ZONING AMENDMENT STAFF REPORT**Date: March 6, 2008****NAME**

LOCATION88 Hillcrest Road
(West side of Hillcrest Road, 270'± North of Cedar Bend Court)**CITY COUNCIL
DISTRICT**

PROPOSED ZONING

LB-2, Limited Neighborhood Business District

PLANNING COMMISSION VICINITY MAP - EXISTING ZONING

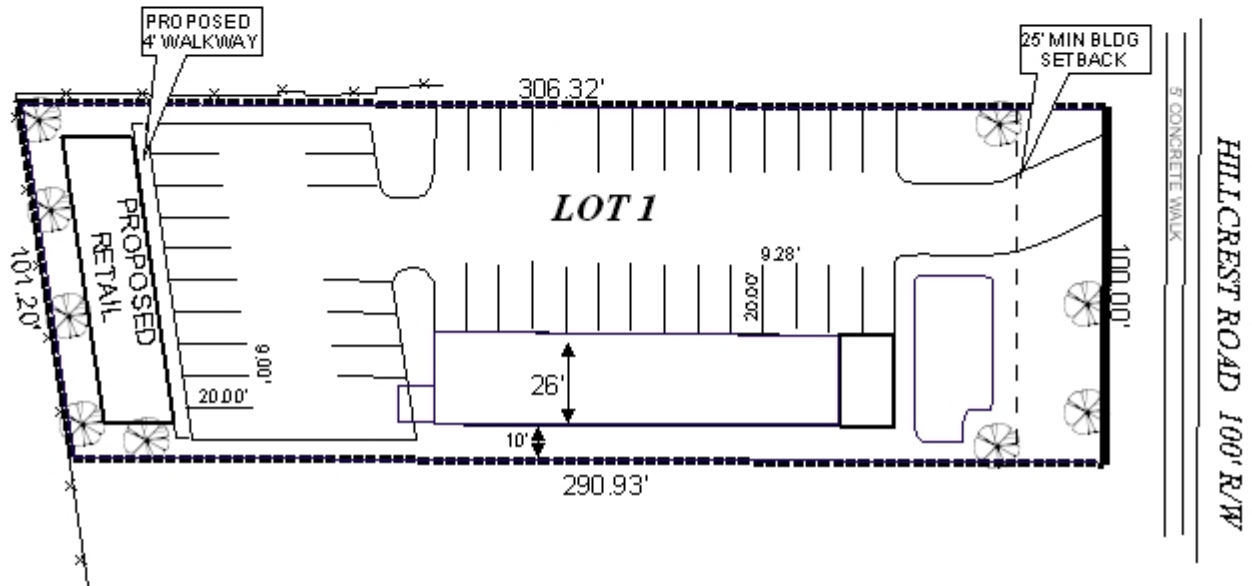
North of the site are dwellings in an R-1, Single-Family Residential District and apartments in an R-3 District, East (across Hillcrest Road) of the site is a credit union in a B-1 District, while West of the site are single-family residences in an R-3, District.
